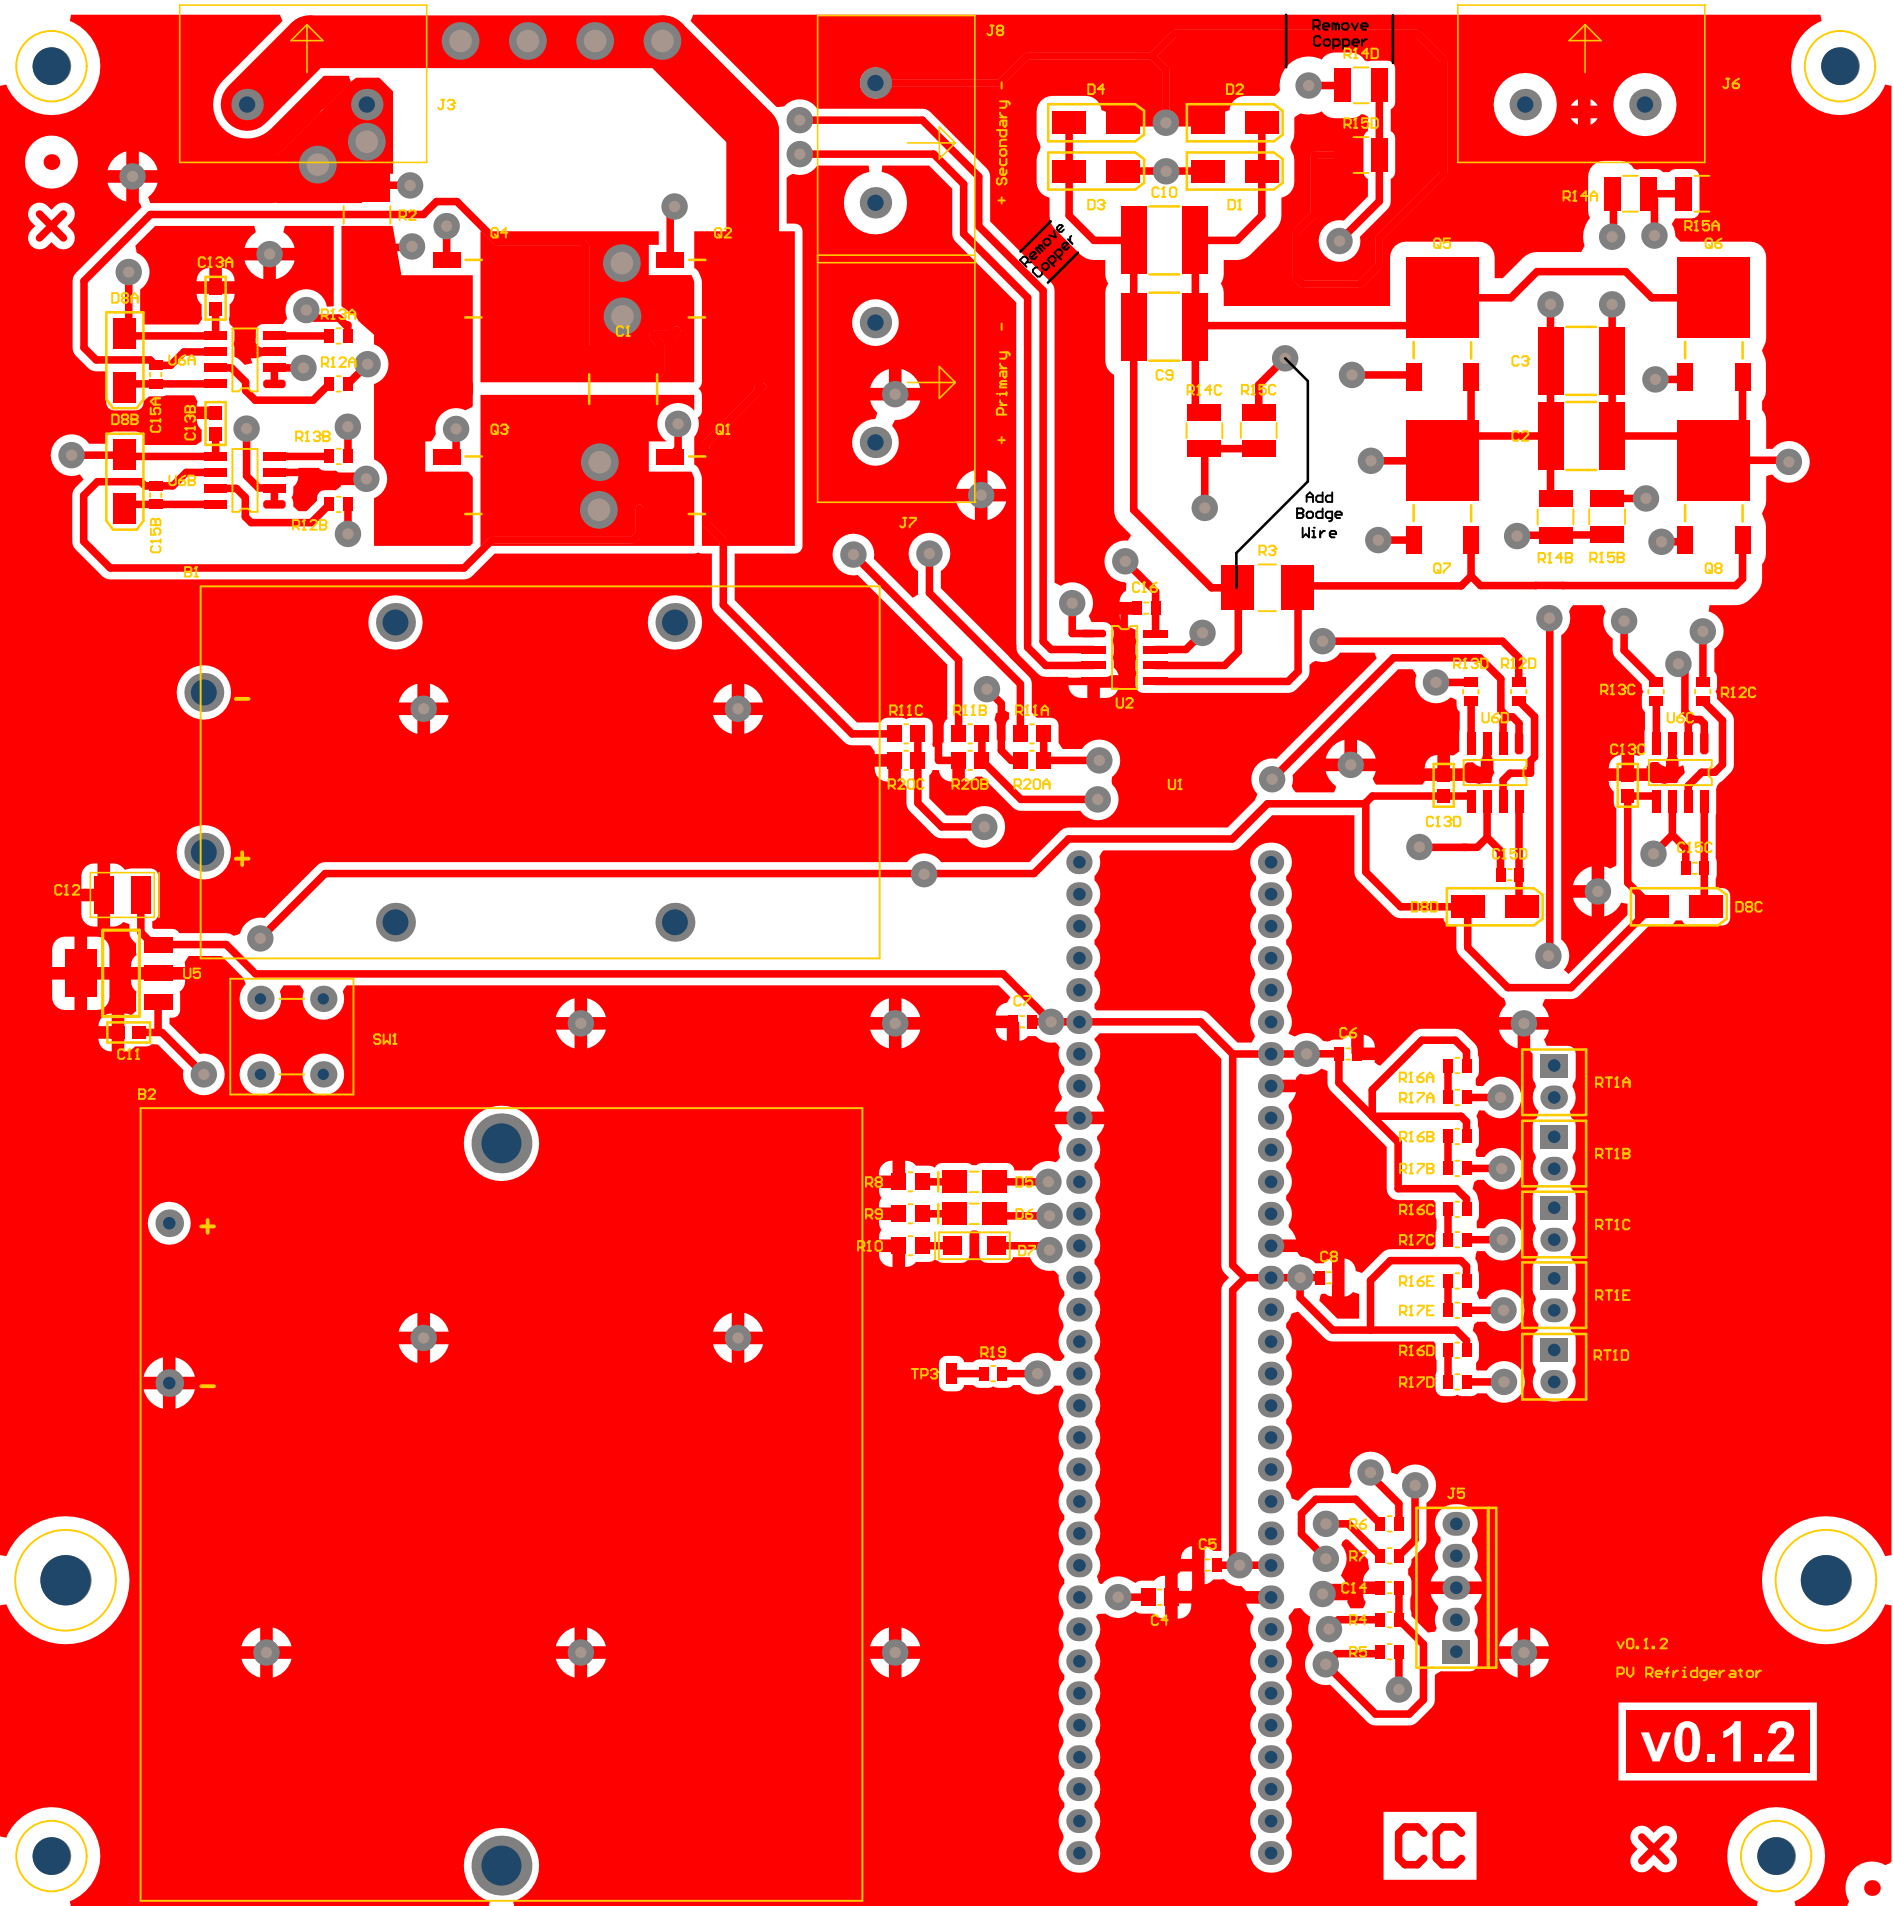
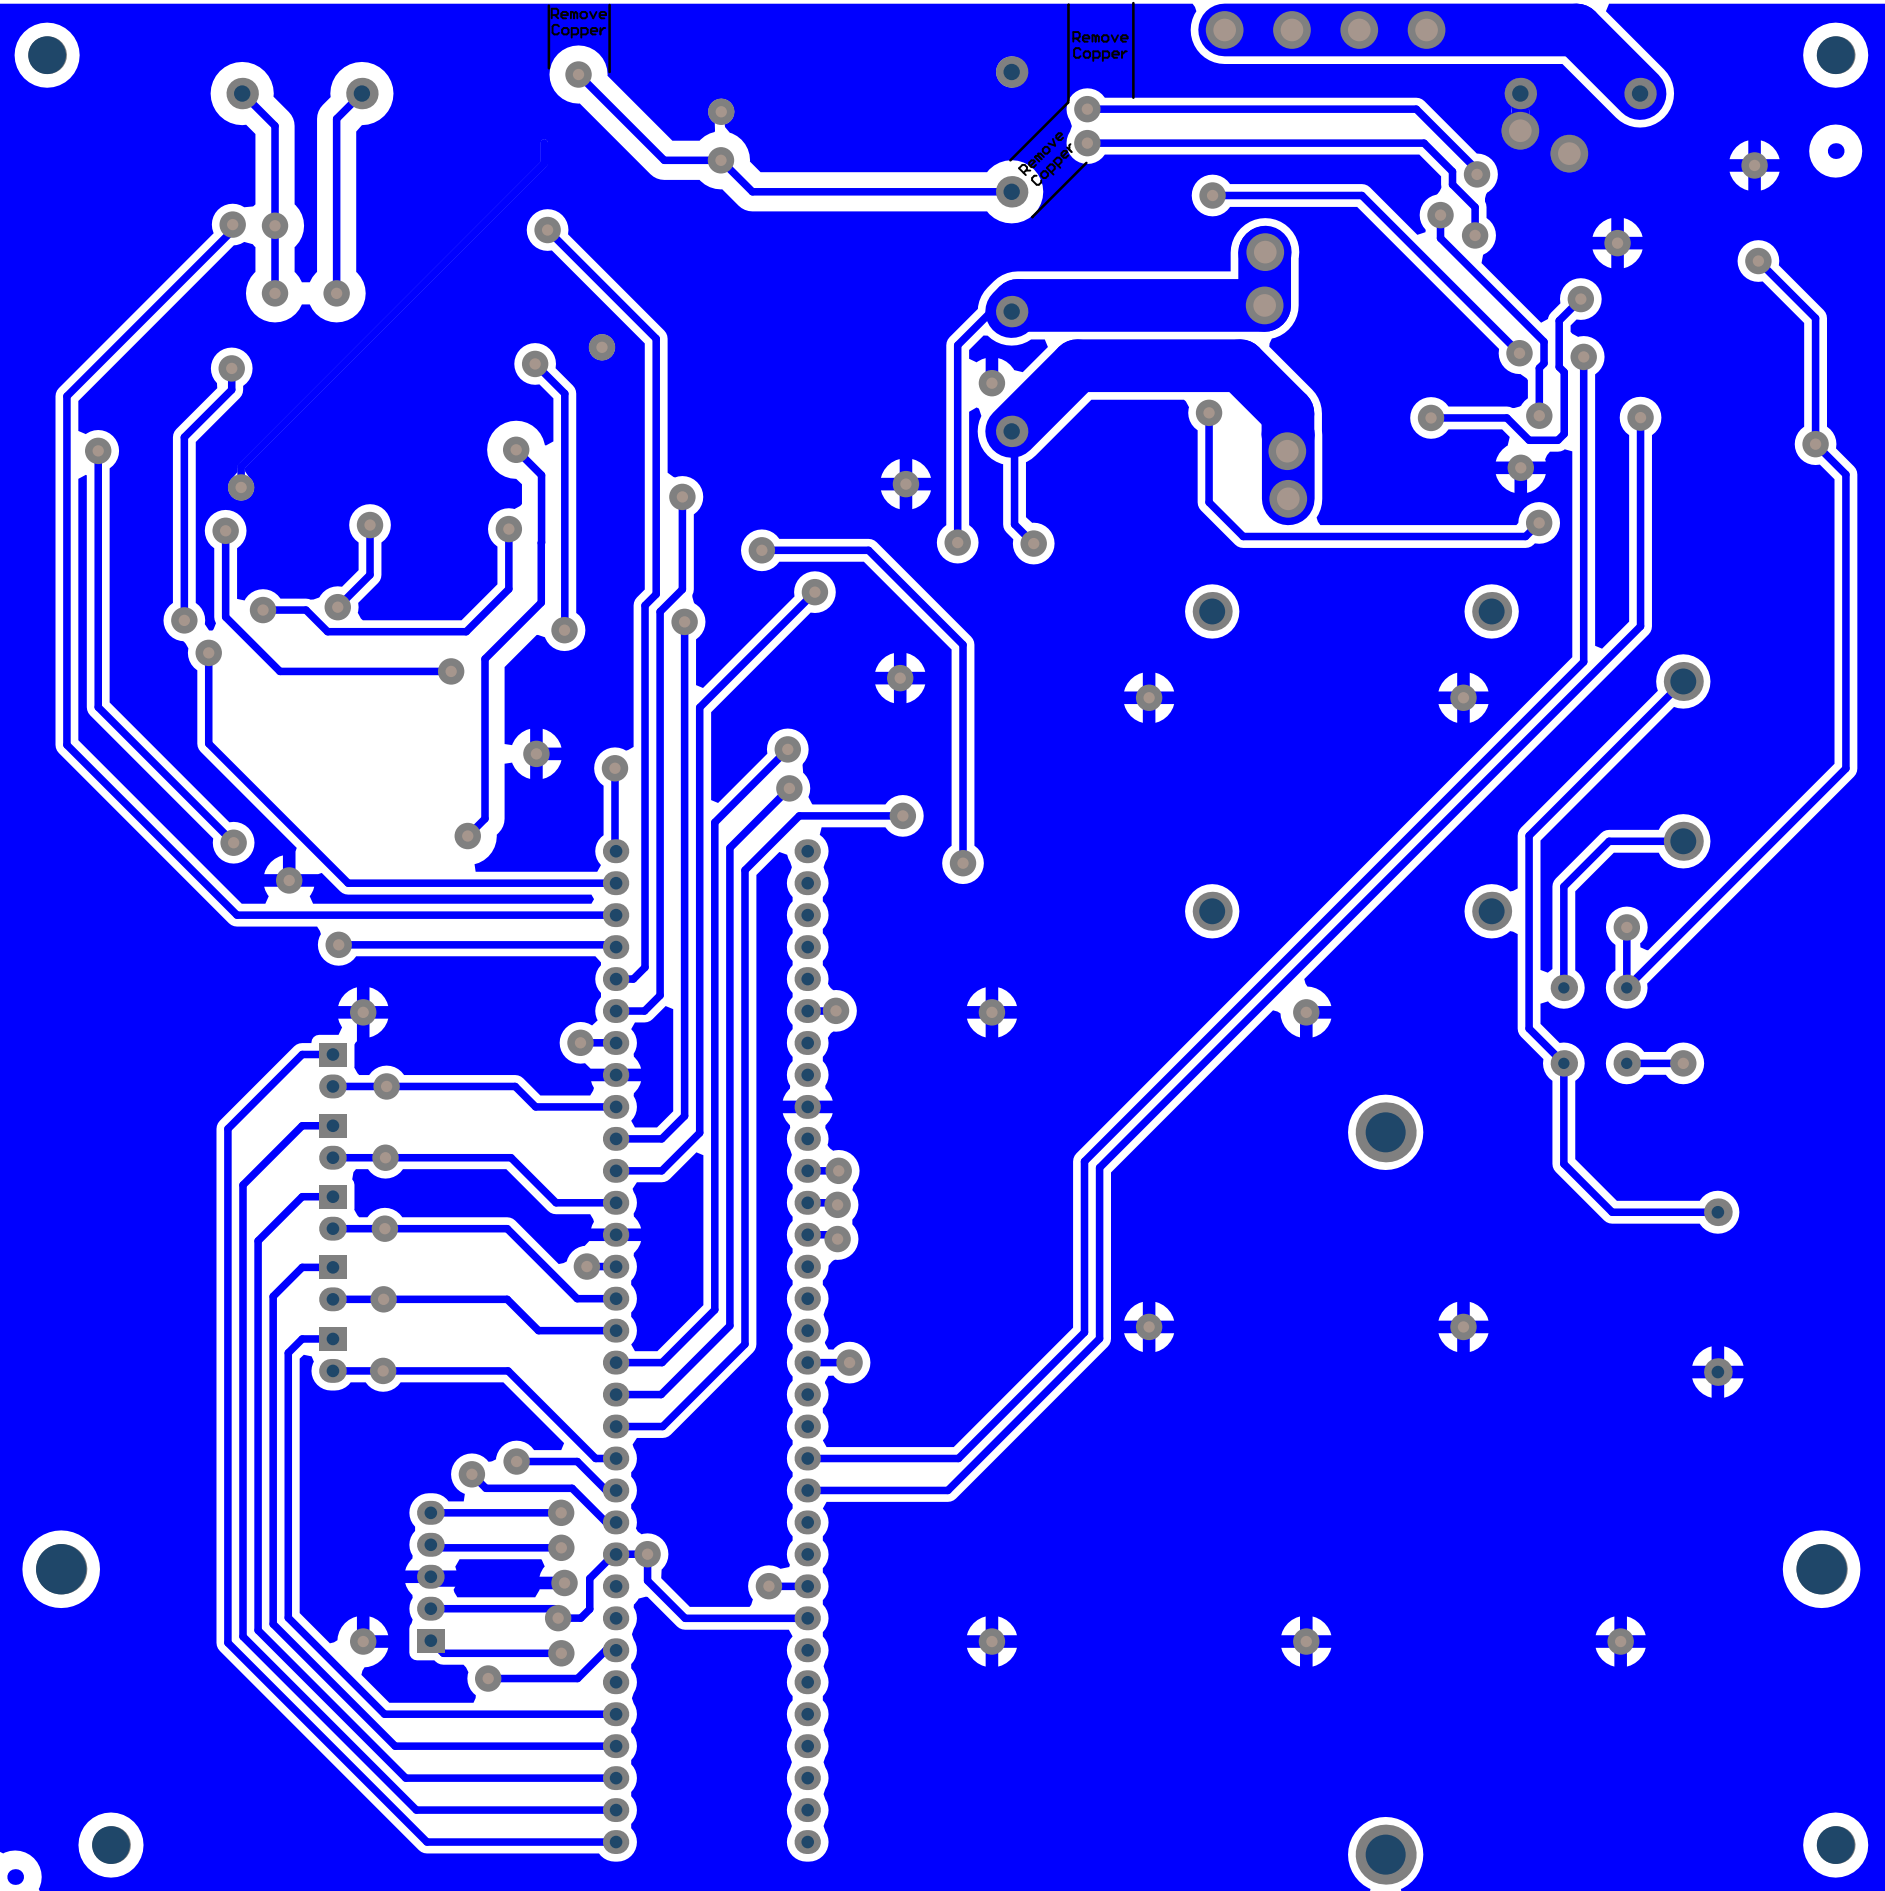
Note: All removed copper needs to be 1.5 mm wide or wider.  
In addition the bodge wire must remain a minimum of 1.5mm away from all other copper and components.

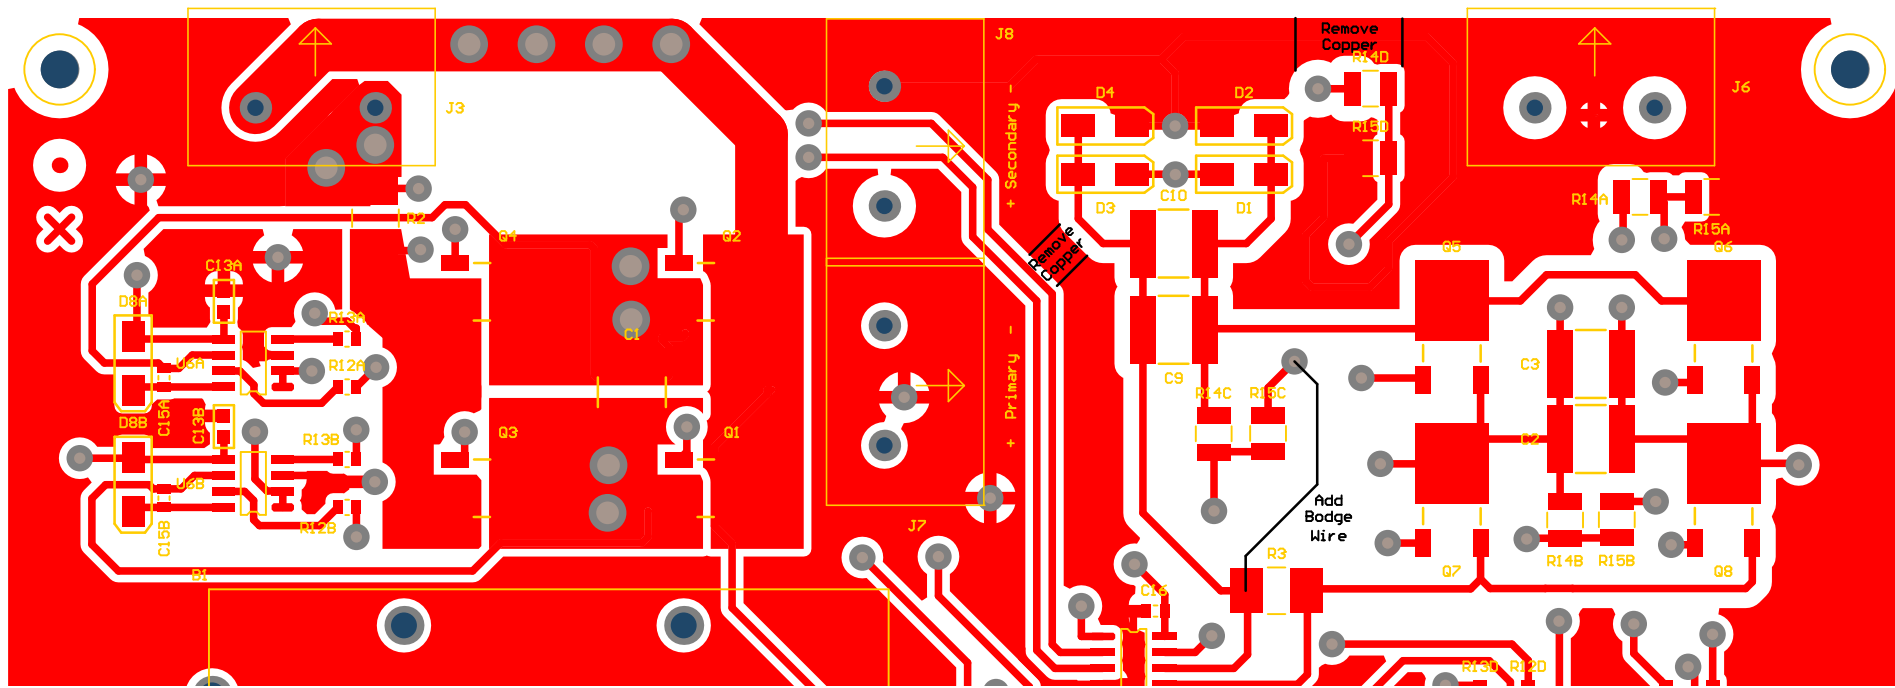
Note: All removed copper needs to be 1.5 mm wide or wider.

Note: All removed copper needs to be 1.5 mm wide or wider.

In addition the bodge wire must remain a minimum of 1.5mm away from all other copper and components.

Note: All removed copper needs to be 1.5 mm wide or wider.
